Tom Howard 9 Sep. 21
Author response to:

Discussion of Towards using state-of-the-art climate models to help constrain estimates of unprecedented UK storm surges

by Tom Howard and Simon David Paul Williams

Discussants: Eleanor D’Arcy and Jonathan Tawn

Figure 1: Extreme skew surge observations against ranked peak tide at Heysham (left) and Sheerness (right).

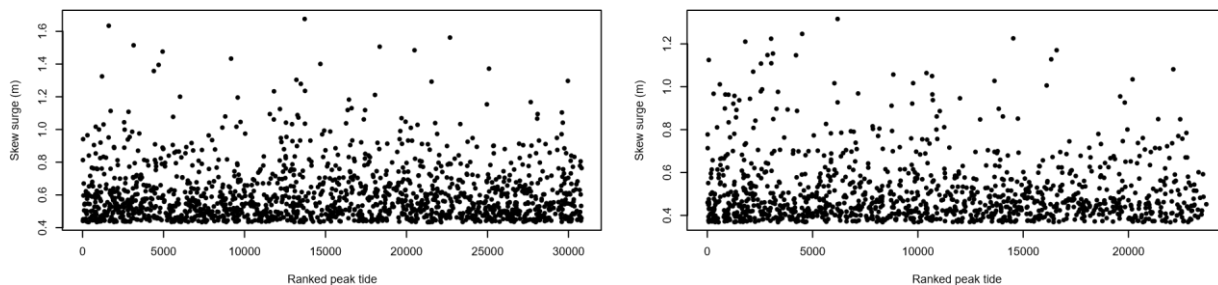
We define extreme skew surges as exceedances of the 0.95 quantile at each site. Figure 1 shows scatter plots of extreme skew surges against their associated ranked peak tide; these are ranked so that 1 corresponds to the smallest observation and n is the largest, where n is the total number of observations. If the two components were independent, we expect extreme skew surges to be uniformly distributed over ranks. We test this using a Kolmogorov-Smirnov test for uniformity; the p value at Heysham is 0.0224 whilst at Sheerness it is 1.40×10^{-7} . Clearly the p value at Sheerness is much smaller, and provides statistical evidence that extreme skew surges are not independent of peak tide. However, at Heysham, there is not sufficient evidence to reject the claim of independence at the 0.01 significance level. This is clear in Figure 1, where more extreme skew surges occur on lower tides at Sheerness - this agrees with your findings and those of Williams et al. (2016).

Figure 2: Monthly distributions of peak tides at Sheerness in February, May, August and October. The probability density function of all peak tides (black) and peak tides associated with extreme skew surge (red) are interpolated onto each distribution.

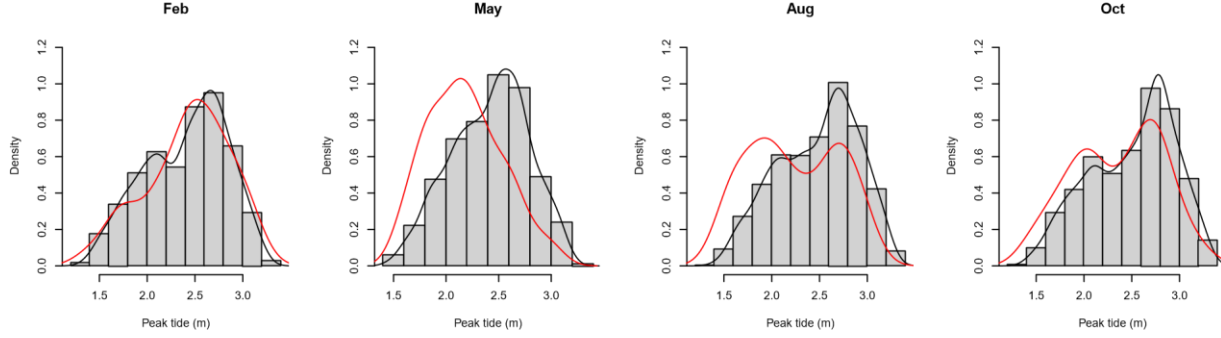
We investigate this further by looking at skew surge and peak tide dependence on a month-by-month basis, using ideas from Williams et al. (2016). Figure 2 compares the distribution of peak tides associated

with all skew surges and the distribution of peak tides associated with extreme skew surges for February, May, August and October. If peak tide and skew surge are independent, these two distributions should be the same, up to sampling variation. We estimate the probability density function (pdf) using a Gaussian kernel density estimate, and use an Anderson-Darling test to check if peak tides come from the same distribution as peak tides associated with extreme skew surges. Figure 2 highlights how the dependence between skew surge and peak tide is changing with the time of year; the distribution of peak tides and the peak tides associated with extreme skew surge are most different in May and least different in February. In May, the mode of the distribution of peaks tides associated with extreme skew surges has shifted to a lower value than the distribution of all peak tides. Results from the Anderson Darling test for every month tell us there is insufficient evidence to reject the null hypothesis that peak tides and the peak tides associated with extreme skew surge come from the same distribution in February, March, September, November and December. In these months, we conclude it is reasonable to assume skew surge and peak tide are independent. In the remaining months, we find sufficient evidence to suggest the two components are dependent. We believe this poses a really interesting area for further research.

This is very interesting. Thank you for including it in your review. In the draft I have added a citation to your forthcoming publication.
